RE: Village at Little Falls Response to Peer Review Comments

Gorrill-Palmer, Inc. July 5, 2007 peer review letter to Brooks More, AICP, Town of Windham's Director of Planning, identified 5 traffic related comments. Each comment, followed by an appropriate response, is provided as follows for your review and ultimate submittal to the Town:

Mr. Brooks More, AICP
Director of Planning
Town of Windham
8 School Street
Windham, ME 04062

Stormwater Management Plan Review

Figure 8-19

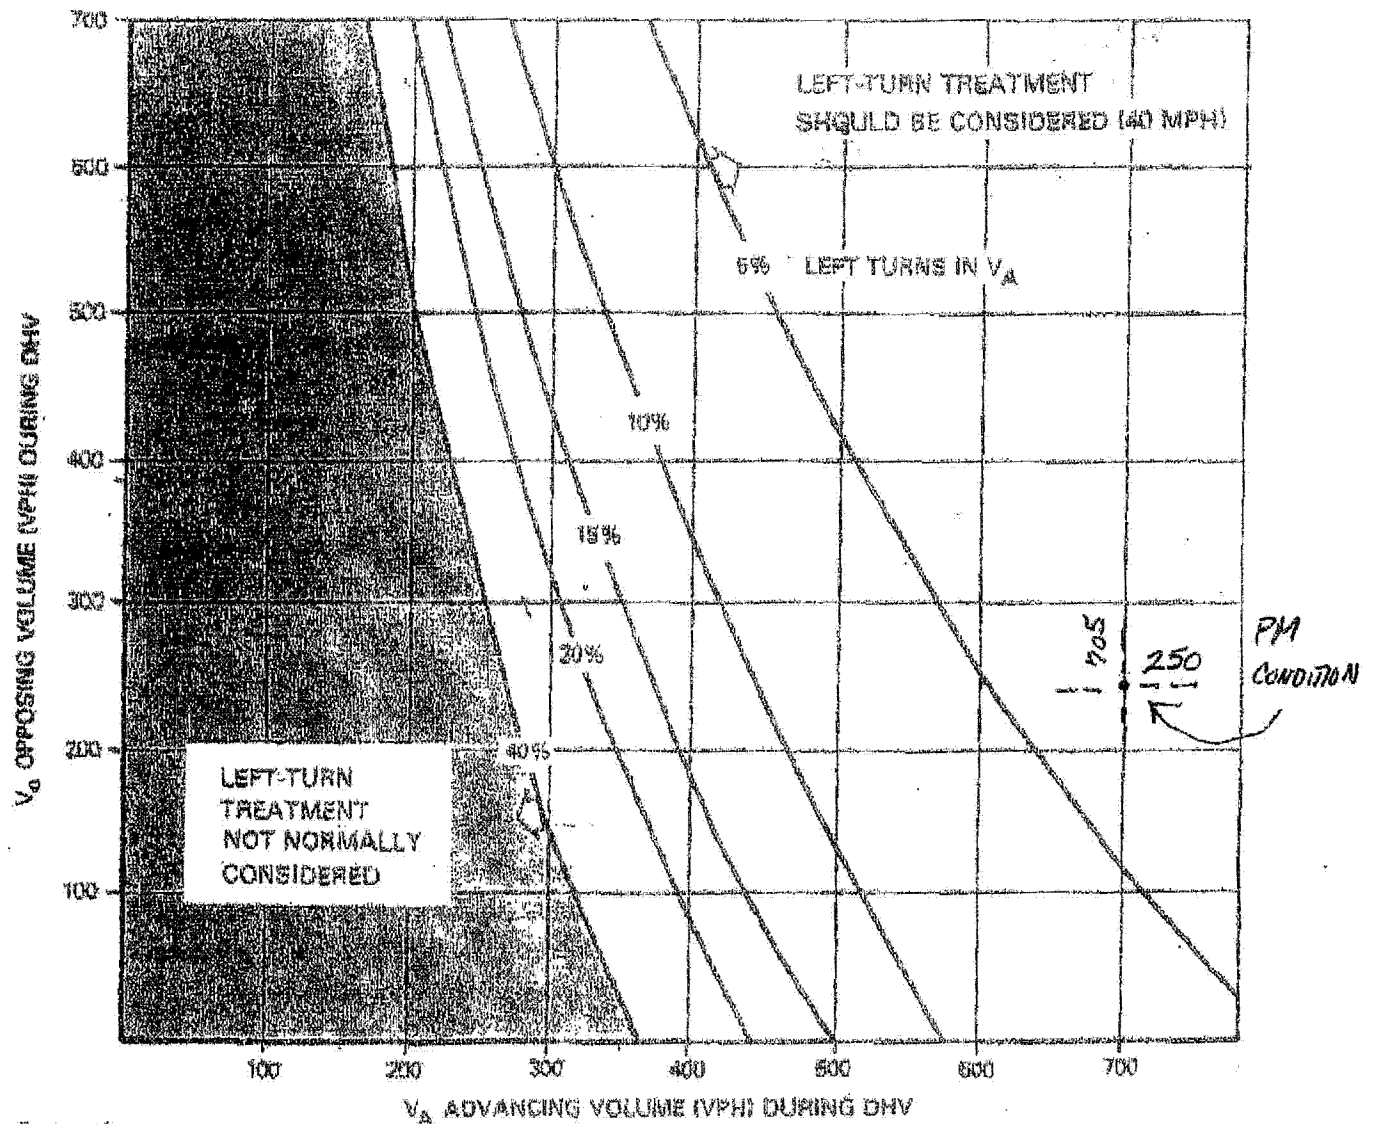
In response to this comment, MDOT's Figure 8-19; Volume Warrants for Left-Turn Lanes at Unsignalized Intersections on 2-Lane Highways (40mph) was evaluated based upon estimated 2009 AM and PM Post-Development traffic conditions. Figures 7 and 8 from the submitted traffic impact study (refer to attached copies) were used as the basis for assessing the need for a separate left-turn lane from westbound River Road. The respective values used for each peak hour condition are noted as follows:

Attached for reference, is a copy of MDOT's Figure 8-19 that depicts the location of noted values for both peak hour conditions. Based upon the defined process a separate left-turn lane is not warranted during the AM peak hour condition and is very minimally warranted for the PM peak hour time period. The 35 vehicles in the PM peak hour attempting to turn left from River Road to Depot Road are opposed by a total of 250 vehicles. The capacity analysis completed for the PM peak hour condition suggests that the highest or "best" level of service is maintained for the left-turn movement from River Road. Further, MDOT's 2002 through 2004 safety data for the intersection would suggest that the intersection is currently not experiencing a safety problem. It would be the opinion of the writer that a separate left-turn lane is not appropriate based upon projected post-development conditions.

PARTIAL SITE PLAN

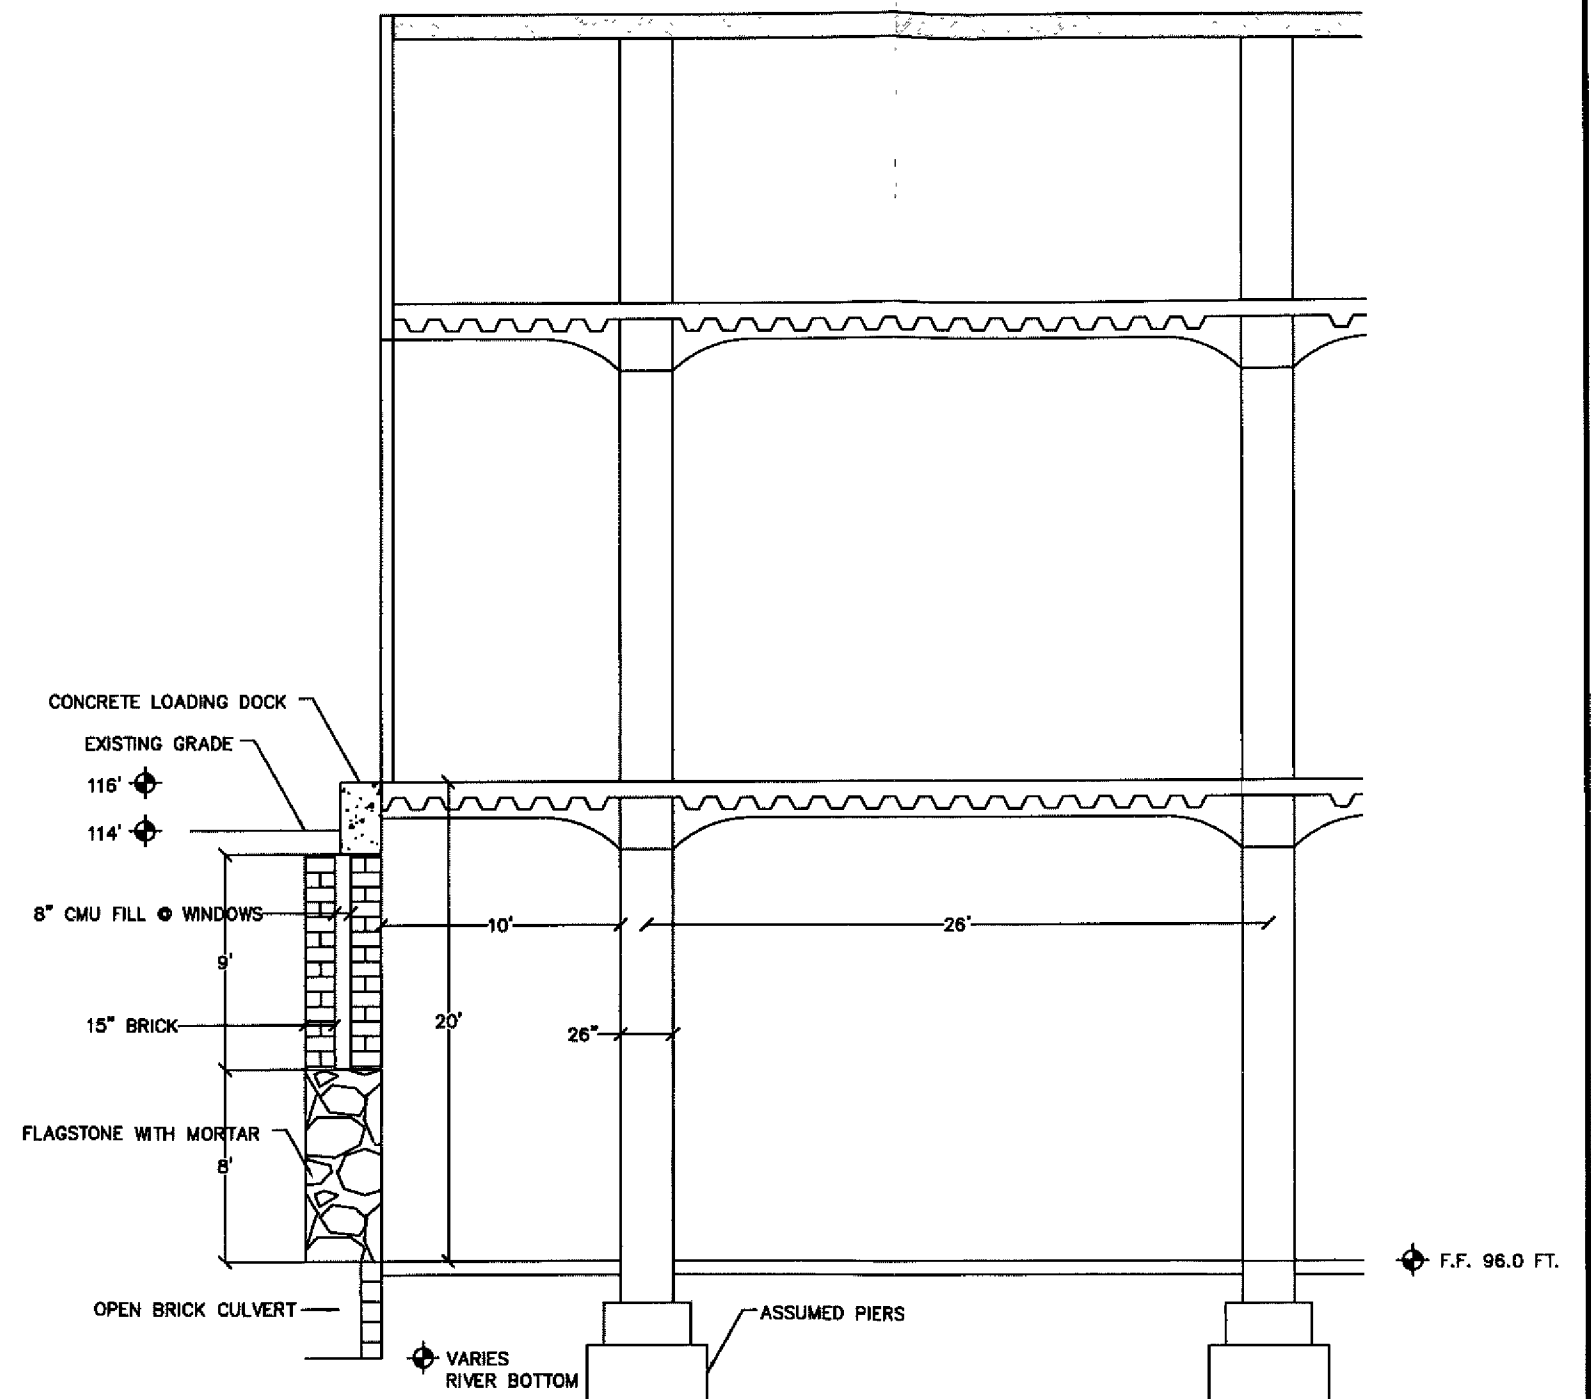
63. Slope grading shown on the partial site plan does not appear to agree with the grading plan (Sheet 6 of 38). The partial site plan shows a top of slope elevation 112 and 2H:1V slopes, compared to the grading plan which shows top of slope elevation 114 and approximately 1.7H:1V slopes, respectively. The plans should be revised accordingly.
64. The extent of riprap shown on the elevation view does not appear to match the riprap detail shown on the riverbank protection detail (sheet 26 of 38). These two plans should be coordinated and revised accordingly.
